Sunrise Coalition Comments on Stormwater Issues at Proposed Bradley Ridge Subdivision

Submitted to Chapel Hill Planning Board on December 17, 2007

Figure 2 – Slide #9 from Sunrise Coalition presentation to Chapel Hill Planning Board on Dec. 4, 2007

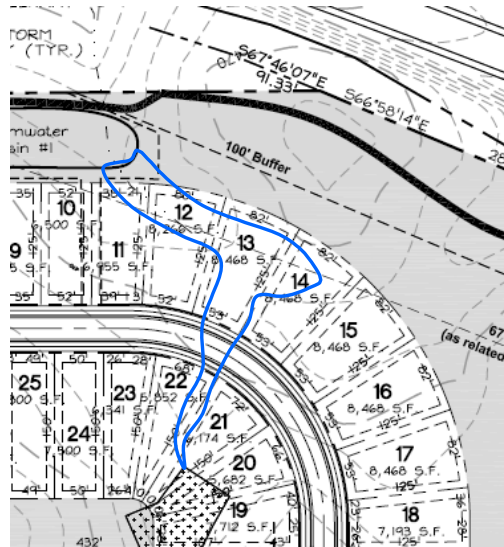
The Applicants' Preliminary Plat and Stormwater Impact Statement do NOT indicate that measures will be taken to minimize impacts to the hydrologic functions of the boggy wet zone in the Basin 1 drainage area. The approximate boundaries of this wet zone are delineated in Figure 2. As noted above, this wet zone includes a "linear wetland" feature that was classified initially by Town Engineers as an intermittent stream and subsequently reclassified.

As currently proposed, the eastern portion of the Bradley Ridge development will disrupt the hydrologic functions of the wet zone shown in Figure 2 and the associated drainage line that

Development and piping of the wet boggy area delineated in Figure 2 will directly connect the entire drainage line with the proposed stormwater Basin 1. Runoff from the two-year storm, as estimated by Mitchell & Westendorf, will increase from 4,603 cubic feet in the current pre-development conditions, to 11,723 cubic feet post-development. The increased stormwater runoff will be accompanied by increases in Total Suspended Solids (TSS) as well as nitrogen, phosphorus and other pollutants. We note that the pretreatment runoff volume may be overestimated as the estimation method (Rational Runoff approach) assumes that the runoff is delivered from its source without the reinfiltration that has been described for this site. If pretreatment runoff is overestimated, a greater reduction in runoff volume from the post-development condition may be required.

Seasonally saturated area: Intermittent Drainage

CH stormwater engineers cited the **significance of the area** and recommended that **disturbance be avoided or minimized.**

Request the determination be revisited to confirm adherence to LUMO –

- important precedent for Town
- Clearly state reasons for determination with reference to LUMO guidelines

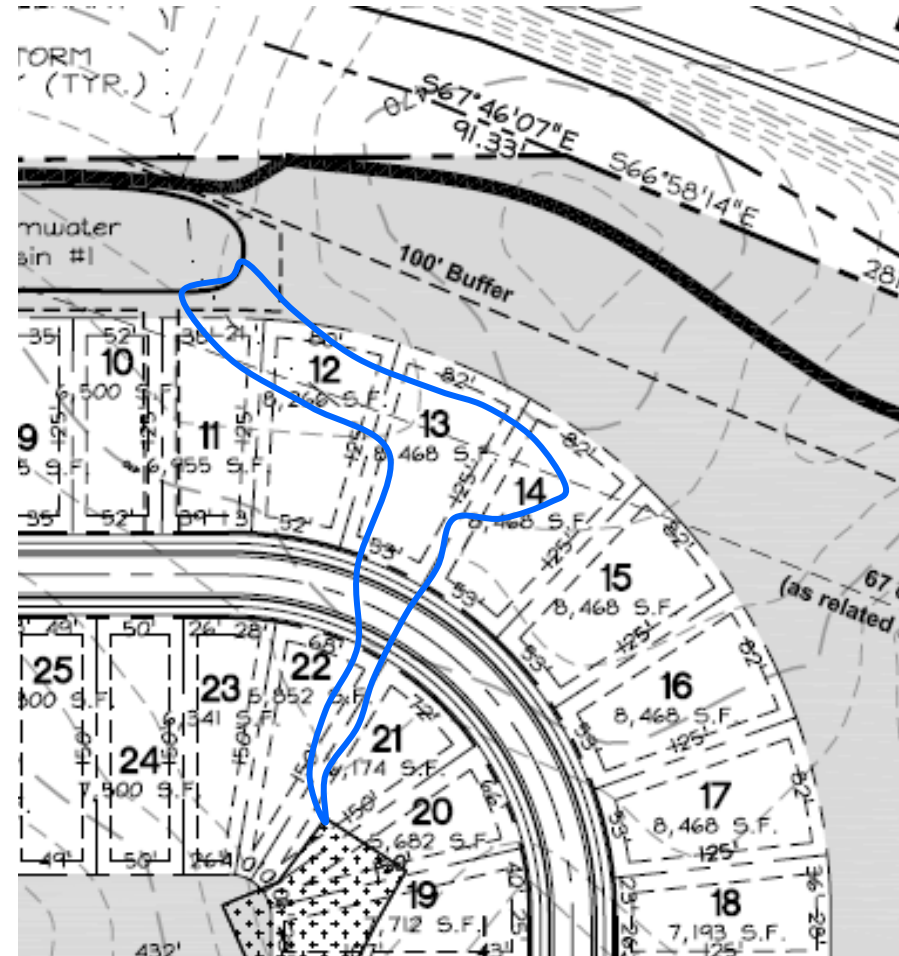
Applicant should be required to conduct a detailed hydrologic study in and around area delineated by blue line in map to right.

Study should concentrate on mapping hydric soil and should include wet periods to observe seasonal high water tables.
